Office Action Summary	Application No. 10/788,788	Applicant(s) GRANDJEAN, MICHEL	
	Examiner Charles E. Cooley	Art Unit 1723

NON-FINAL OFFICE ACTION

EP 1 050 335 A1

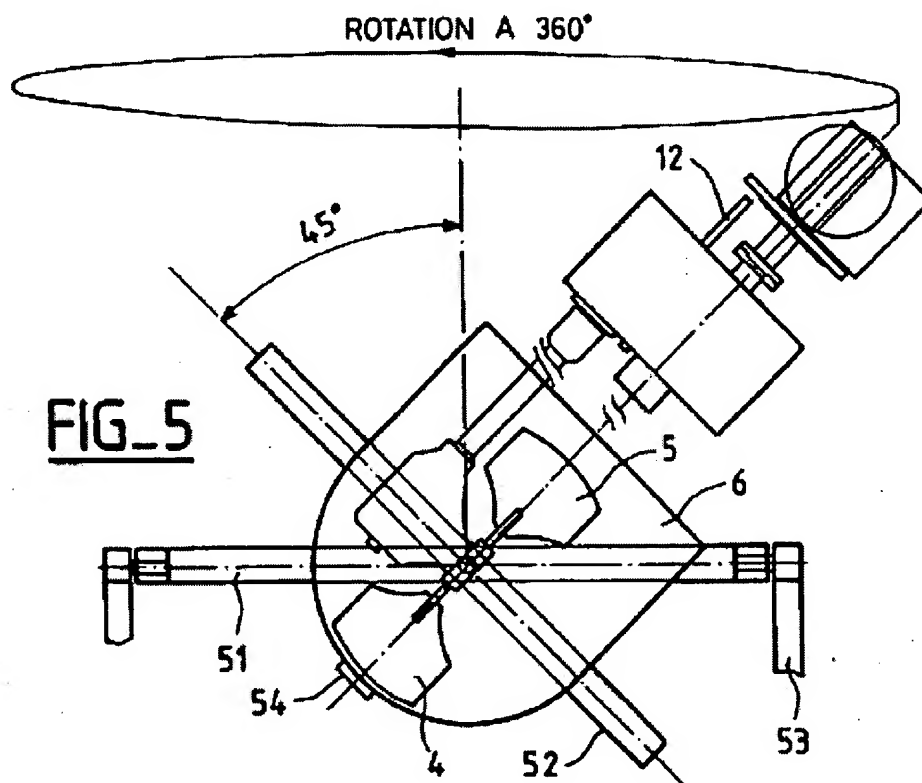
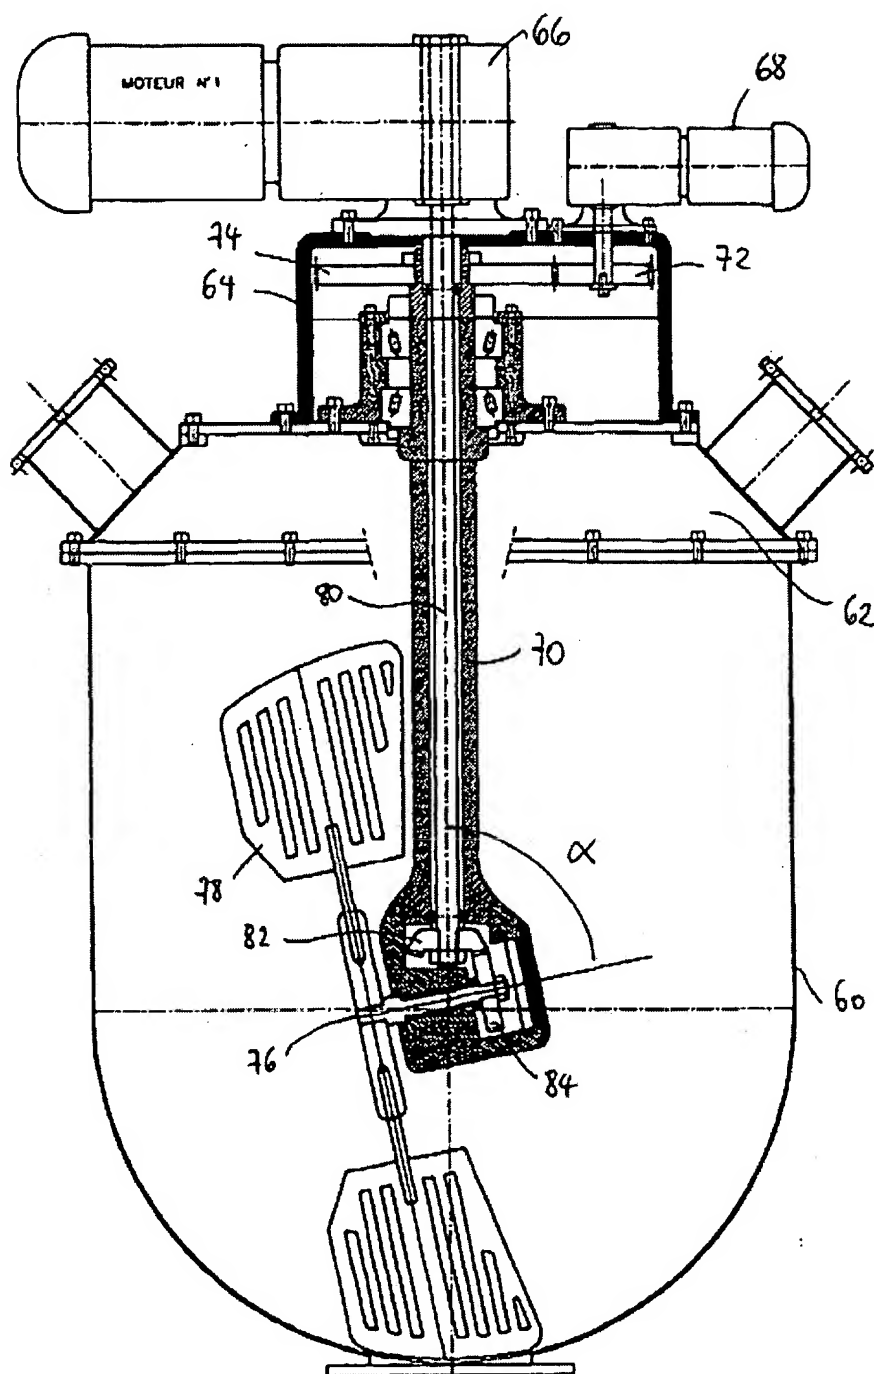
12. Claims 1-10, 12, 19, and 20 are rejected under 35 U.S.C. 102(b) as being clearly anticipated by EP 1050335 A1.

EP 1050335 A1 clearly discloses the recited mixer in Figs. 5 and 6 below and note the attached abstract describing the claimed subject matter. Fig. 5 immediately below shows the subject matter of claim 20 (the cradle arrangement).
